Access Compliance Report

Public Rights-of-Way

(Curb Ramps)

Intersection ID: 20018	Main Street: PARK_RD	Cross Street: FAIRVIEW_RD	Location: NE
ADA ID: B54A0F9E4795	Ramp Type: Perp	Initial Pass/Fail: Fail	Overall Compliance: No
Severity Score: 37.5			
Codes/Mitigation Info/Possible Solution		Field Measurements/Component Compliance

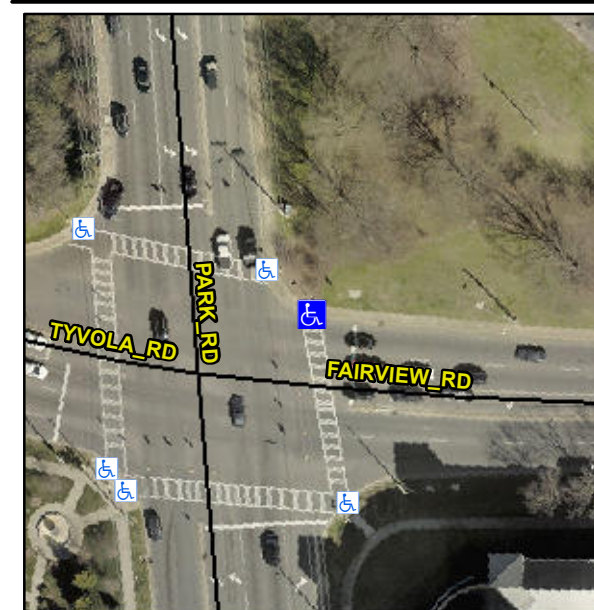
R304.2.2, R304.5.3

Compliance	Description	Data	Compliance	Description	Data
N/A	Ramp Length (in)	63.0	No	Ramp Slope (%)	9.1
Yes	Ramp Width (in)	48.0	No	Ramp XSlope (%)	9.2
N/A	Flare Type LT	N/A	N/A	Flare Type RT	N/A
N/A	Flare Slope LT (%)	N/A	N/A	Flare Slope RT (%)	N/A
N/A	Flare Traversable LT?	N/A	N/A	Flare Traversable RT?	N/A
N/A	Landing Length (in)	N/A	N/A	DWS Provided?	N/A
N/A	Landing Width (in)	N/A	N/A	DWS Contrast?	N/A
N/A	Landing Slope (%)	N/A	N/A	DWS Length (in)	N/A
N/A	Landing X Slope (%)	N/A	N/A	DWS Full Width?	N/A
N/A	Landing Curb? (Y/N)	N/A	N/A	DWS Offset (in)	N/A
N/A	Shared Landing?	N/A			
N/A	Gutter Ponding?	N/A	N/A	Gutter Slope (%)	N/A
N/A	Gutter Lip Ht (in)	N/A	N/A	Gutter X Slope (%)	N/A
N/A	Painted X Walk1?	Yes	N/A	Painted X Walk2?	N/A
	X Walk 1 Direction	To S		X Walk 2 Direction	N/A
N/A	X Walk 1 Width (in)	110.0	N/A	X Walk 2 Width (in)	N/A
	X Walk 1 Slope (%)	3.9		X Walk 2 Slope (%)	N/A
	X Walk 1 X Slope (%)	3.7		X Walk 2 X Slope (%)	N/A

Remove & Replace Entire Ramp.
